February 4, 2000

ULNRC-4183

**DOCKET NUMBER 50-483
CALLAWAY PLANT UNIT 1
UNION ELECTRIC CO.
FACILITY OPERATING LICENSE NPF-30
Proposed Changes to NRC Resident Inspector Personnel Office Space
Re: 10 CFR 50.70(b)(2)**

Existing

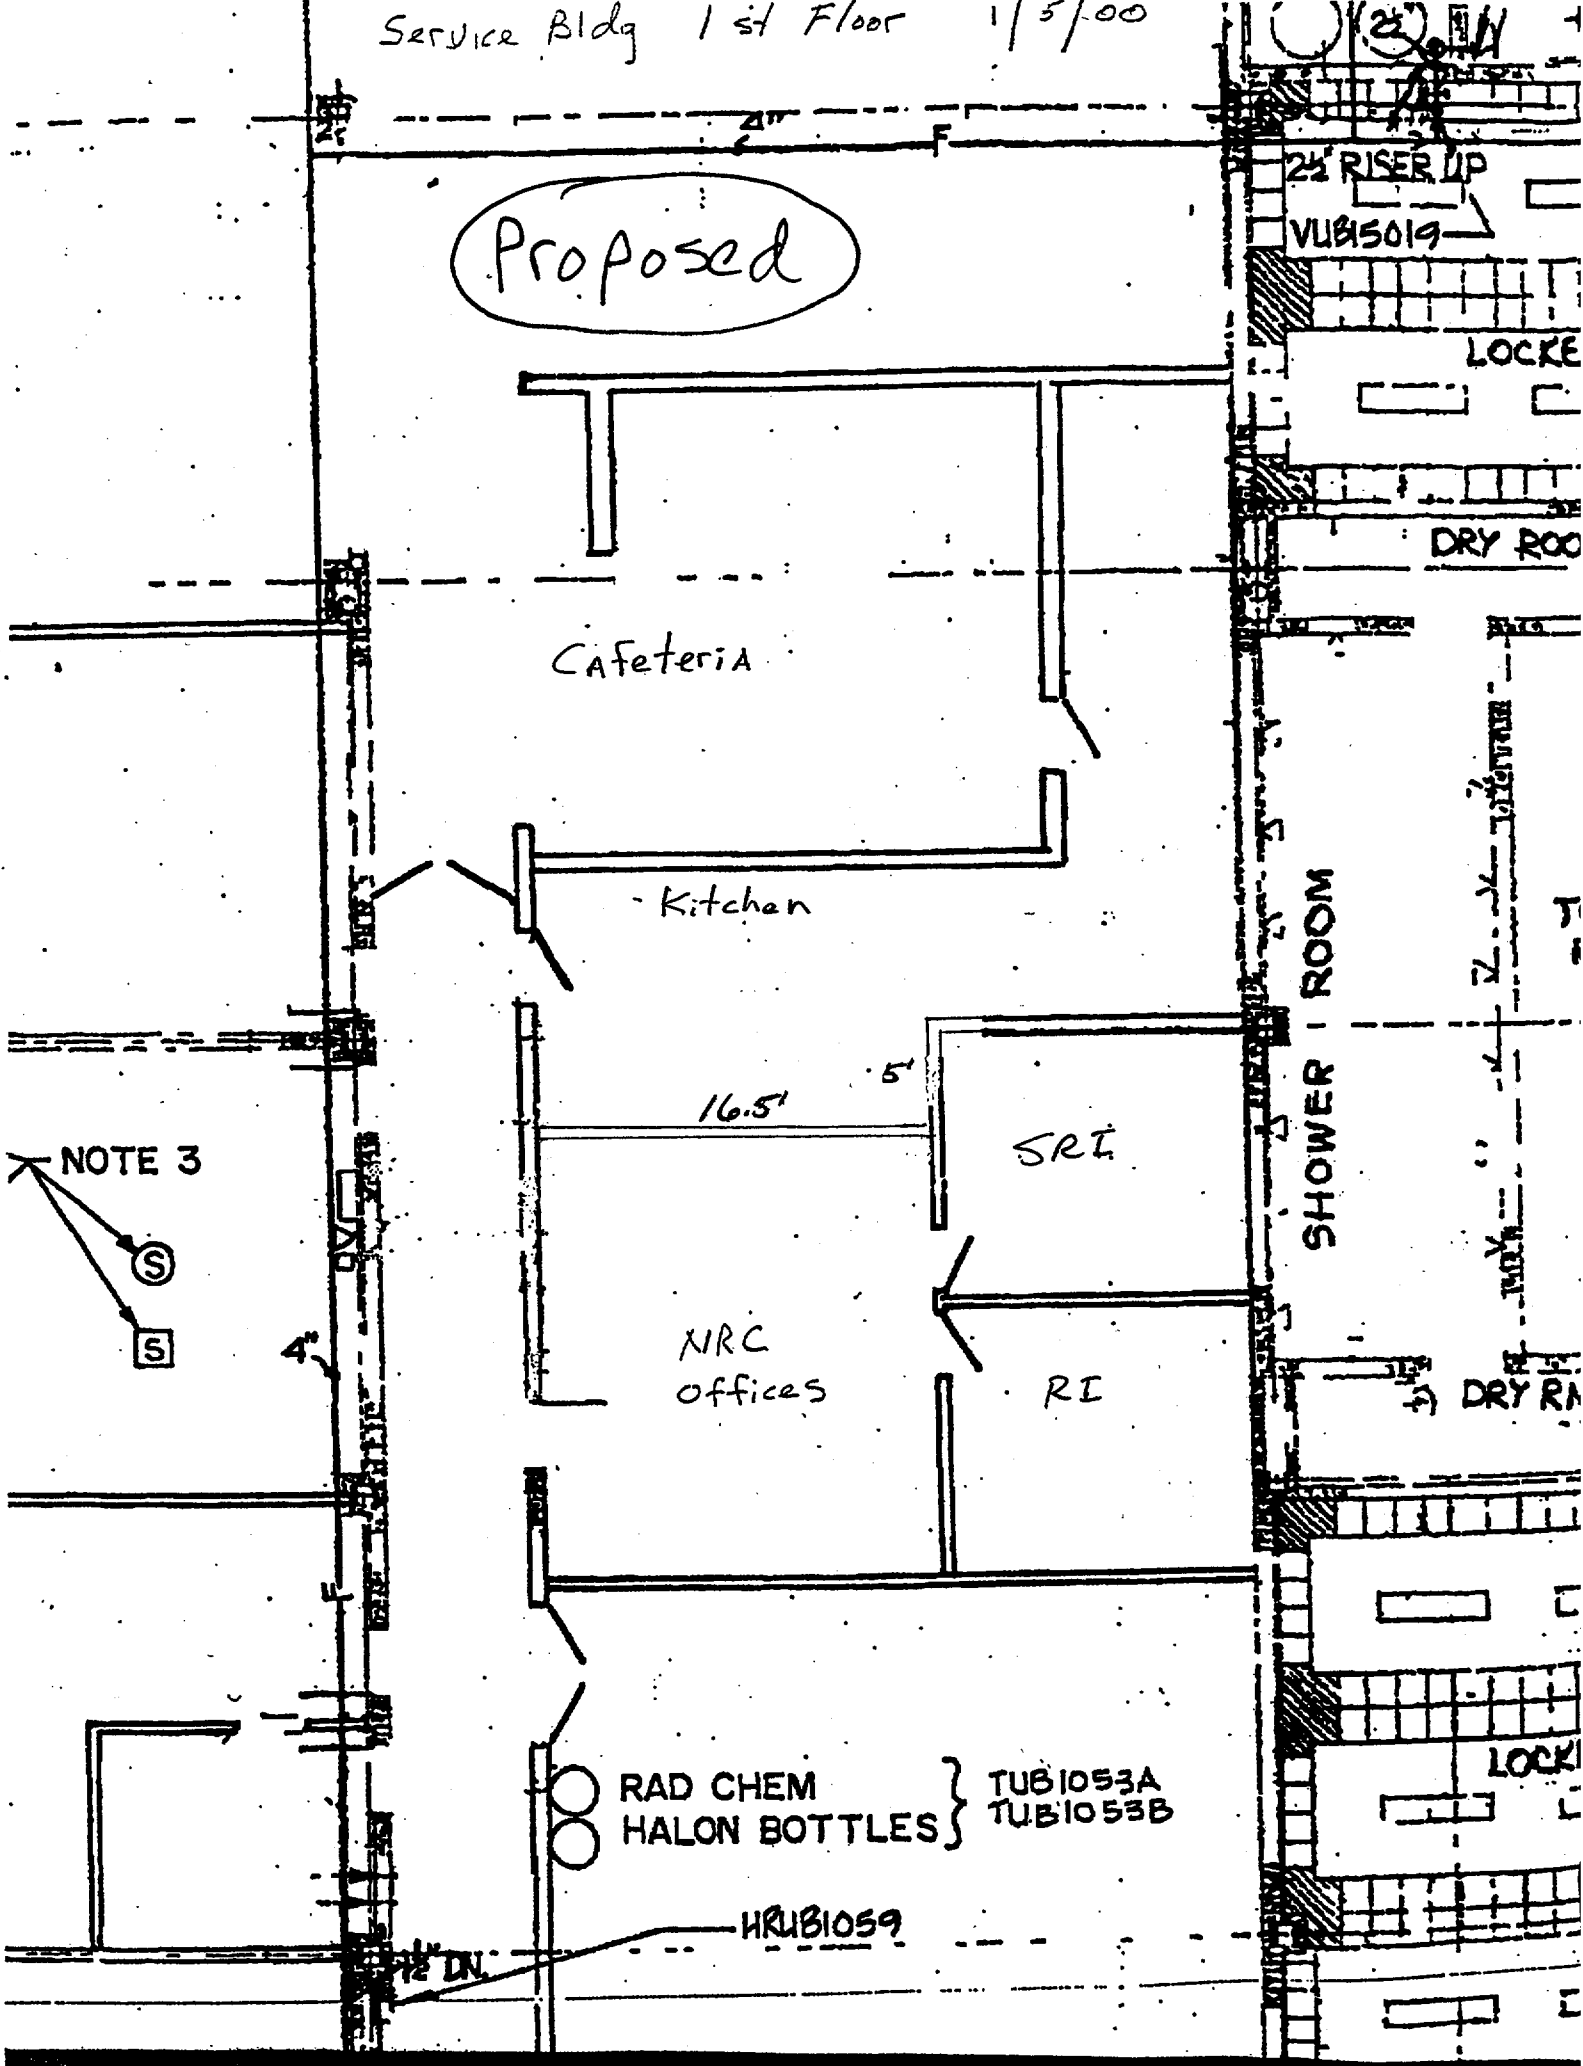
AmerenUE desires to remodel their cafeteria facilities to provide for improved food service, as well as resolve personal safety concerns stemming from overcrowding. In order to accomplish these objectives, it will be necessary to move portions of the wall located between the cafeteria and the Callaway Plant NRC Resident Inspector Office.

The proposed change will result in a total office area of 650 square feet. The office space specifically provided for the Senior Resident Inspector and the Resident Inspector is approximately 350 square feet and is unaffected by the proposed change. However, the general use area will be reduced from approximately 380 square feet to 300 square feet. This area is currently utilized for the part-time NRC secretary and a conference area. While this change is an imposition on the NRC staff, it is desired that the NRC office remain in the Service Building, which is the primary office building at Callaway.

It is our current practice to augment the designated NRC office space with conference rooms to support inspection efforts and visits by transient NRC personnel. In conjunction with the remodeling, additional electrical receptacles will be installed to accommodate the current complement of NRC office equipment.

Attached for reference are drawings of the current office area and the proposed change. The drawing scale is approximately 1/8 inch per foot.

Existing

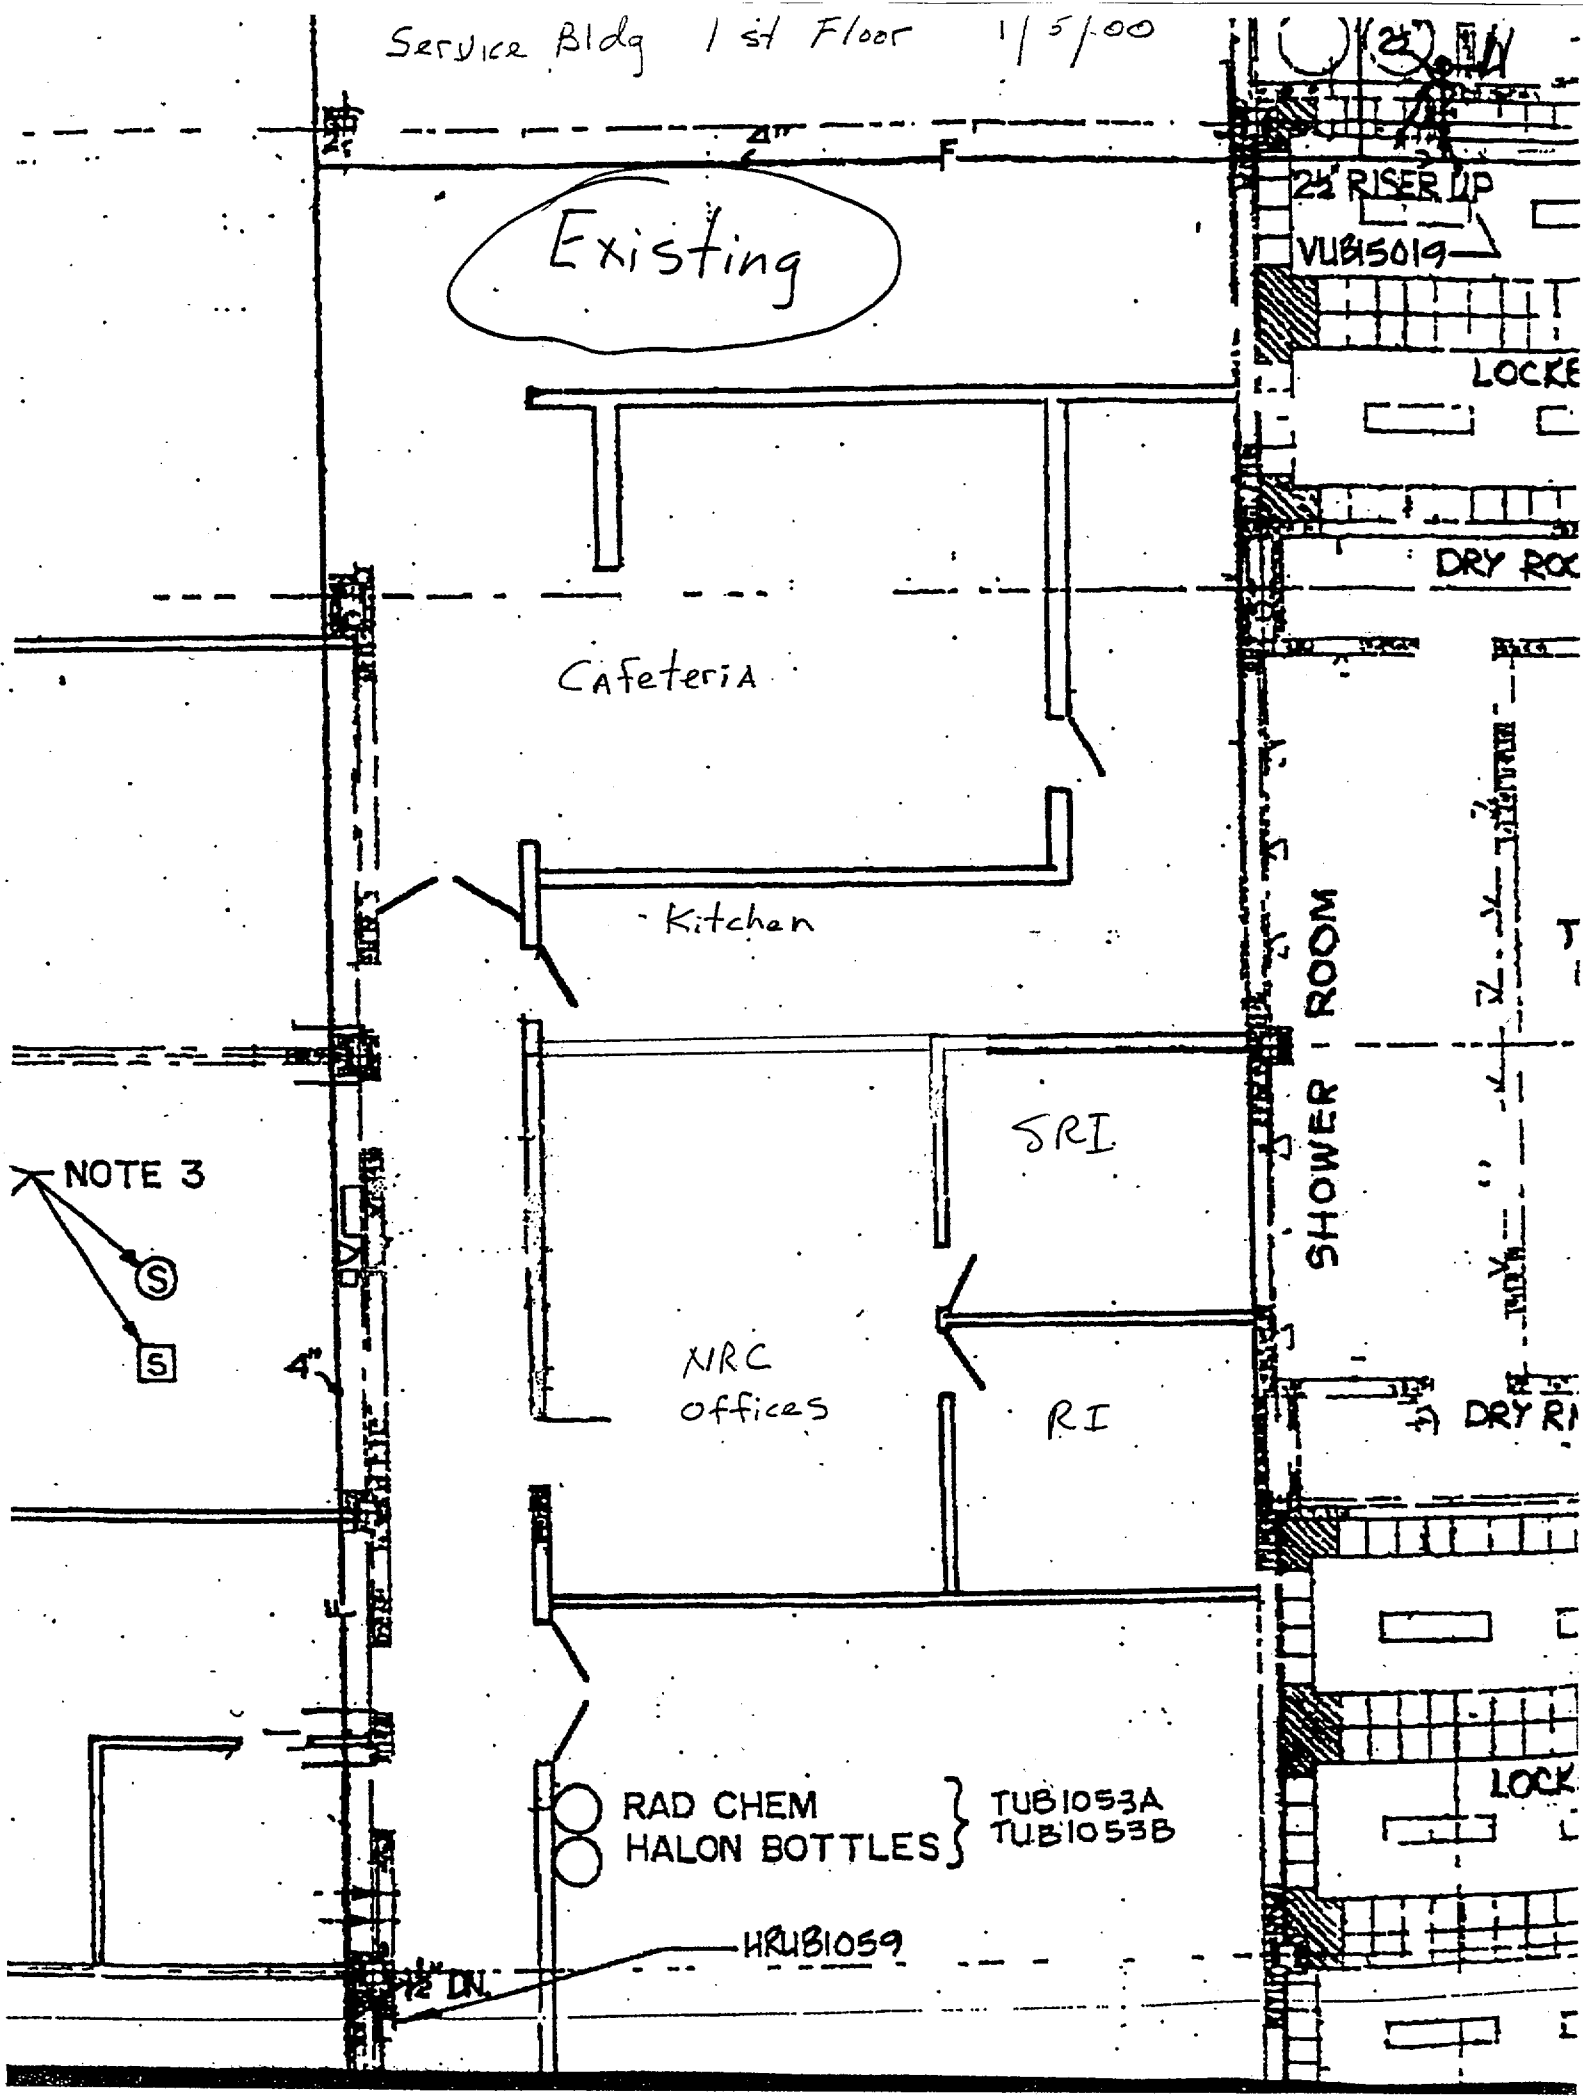
AmerenUE desires to remodel their cafeteria facilities to provide for improved food service, as well as resolve personal safety concerns stemming from overcrowding. In order to accomplish these objectives, it will be necessary to move portions of the wall located between the cafeteria and the Callaway Plant NRC Resident Inspector Office.

The proposed change will result in a total office area of 650 square feet. The office space specifically provided for the Senior Resident Inspector and the Resident Inspector is approximately 350 square feet and is unaffected by the proposed change. However, the general use area will be reduced from approximately 380 square feet to 300 square feet. This area is currently utilized for the part-time NRC secretary and a conference area. While this change is an imposition on the NRC staff, it is desired that the NRC office remain in the Service Building, which is the primary office building at Callaway.

It is our current practice to augment the designated NRC office space with conference rooms to support inspection efforts and visits by transient NRC personnel. In conjunction with the remodeling, additional electrical receptacles will be installed to accommodate the current complement of NRC office equipment.

Attached for reference are drawings of the current office area and the proposed change. The drawing scale is approximately 1/8 inch per foot.
